ro	:	The	Files	(Project	2531)
----	---	-----	-------	----------	-------

SUBJ: Modification of Zenith Royal 500D Receiver

FIGURE L

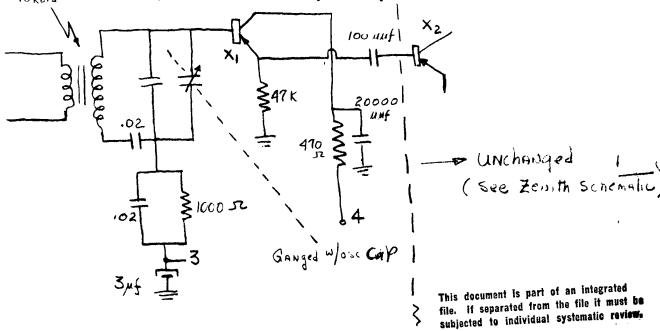
- 1. A brief study was made of the RF and oscillator stages of the Zenith receiver to determine whether it could be converted for operation in the 3 to 6 mc range without the extensive redesign and repackaging necessary in the RR-33.
- 2. The following changes were made in the receiver. (Refer to the partial schematic of Figure 1 and the schematic for the Zenith Royal 500D which is attached).
 - The RF stage was converted to an emitter follower by removing C5, R3, and L2.
 - R5 was replaced by a 47K resistor. (b)
 - C8 was replaced by a 100 uuf capacitor which was connected back to the emitter of X1.
 - (d) 175 turns were removed from the oscillator coil L3.
 - The oscillator transistor (2N409) would not oscillate above 4.5 mc. It was replaced by a 2N247.
- (f) L1 removed and replaced by a toroid. ToRoid
